# 7.1.3 TPA/55974 - 9A COOMBS AVENUE OAKLEIGH SOUTH - CONSTRUCTION OF TWENTY-TWO (22) DWELLINGS

#### **EXECUTIVE SUMMARY**

The proposal is considered inconsistent with the relevant provisions of the Monash Planning Scheme, and it is recommended that the application be refused.

3D Interpretation of Proposal

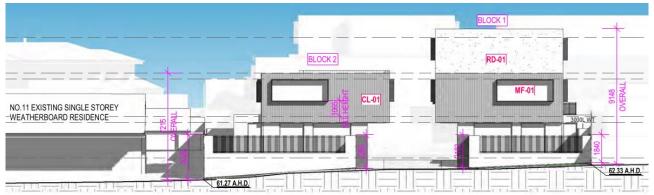
Notwithstanding the recently completed Amara Estate at the rear of the site, the proposal's highly contemporary built form with block-like walls, flat roofs and minimally articulated facades, is at odds with the surrounding existing dwellings.

The Neighbourhood character strategy also seeks to support buildings that front the street and provide articulated upper levels to minimise the impression of building bulk, and provide separation between dwellings constructed on the same site to break up built form and support additional landscaping

Although there is separation of the 22 dwellings into 4 'blocks', each of these blocks present as long continuous expanses of attached walls running in a north-south direction, ranging in length from 27.9 metres (Block 4) to 45.9 metres (Block 1). Block 4 at the rear of the site has a small break between three storey townhouses 404 and 405 but the minimal separation proposed has no impact and does not provide any relief and articulation to the built form when viewed either internally or externally from the site. The 34-metre-long western side of Block 1 will also be highly visible from Coombs Avenue given the future public open space located on number 9 Coombs Avenue.

North Elevation Blocks 3 and 4

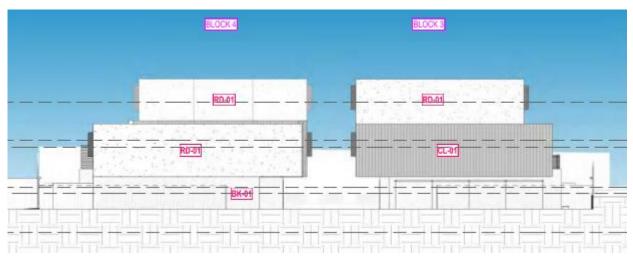
The east-west separation between the proposed blocks is also minimal, with a distance of 3.1 metres between the upper floor levels that cantilever over the common driveway for the full length of the blocks.

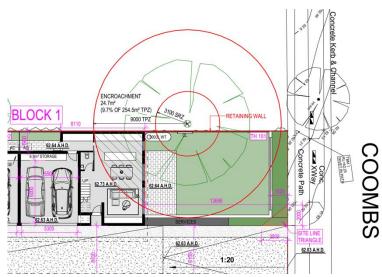
The reverse living arrangement of the proposal combined with the provision of balconies in-lieu of ground level open space, results in a serious lack of garden space to provide room for canopy trees and create a visual buffer between the expansive buildings proposed and adjoining properties.

The proposed narrow side setbacks to property boundaries also severely restricts the planting of any large trees, of particular concern is the 900mm setback from the western boundary abutting the future park at 9 Coombs Avenue.

Part of ground floor plan showing extent of encroachment in the TPZ

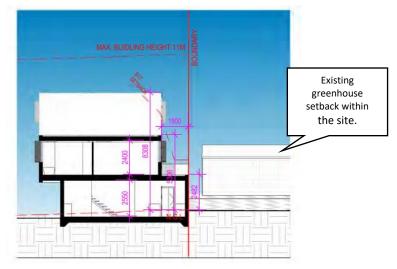
The proposal will also impact the ability to retain the 12 metre high Flowering Gum (Tree 6) located within the future public open space on 9 Coombs Avenue, directly adjoining the western boundary fence.

The applicant's arborist recommends that 'construction within the Tree Protection Zone (TPZ) and Structural Root Zone (SRZ) of Tree 6 should be performed using root-sensitive construction techniques e.g. at or above grade with permeable paving'.

The proposal does not heed this advice and provides excavation for the construction of Block 1, a retaining wall, non-permeable paving, a water tank and fencing within the TPZ. This will likely have a detrimental impact on the health and longevity of Council's tree.

Impression of driveway with no landscaping or sense of address

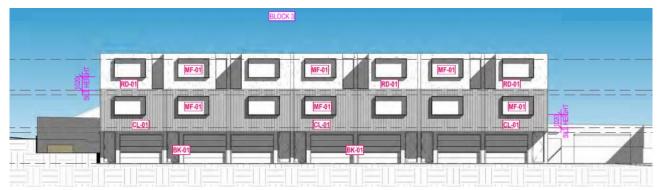
There are no dwelling entries facing Coombs Avenue, with each front door facing and opening onto the central driveway. There is no sense of personal address or transitional space around these front doors, and no landscaping proposed within this central driveway area, except adjacent to the central communal open space areas.

Letterboxes and site services in the front setback will remove the meagre planting proposed adjoining the fences running along the driveway. The visual result will be a long driveway gun barrel, and particularly severe when combined with the cantilevered upper levels.

There are also no ground level windows facing the common driveway in Blocks 1, 3 and 4. In Block 2 Townhouses 202, 203 and 204 each have one bedroom window facing the driveway, providing the only surveillance of common property at ground level in the entire development. These habitable room windows are located too close to the central driveway (under Standard B15) with poor outlook and separation from vehicular noise within the development.

There is also little surveillance from the cantilevered upper levels, which obscure views down into the common driveway. Only 4 living rooms with windows face this area, with bedroom windows likely to be negatively impacted due to insufficient setback from the shared driveway.
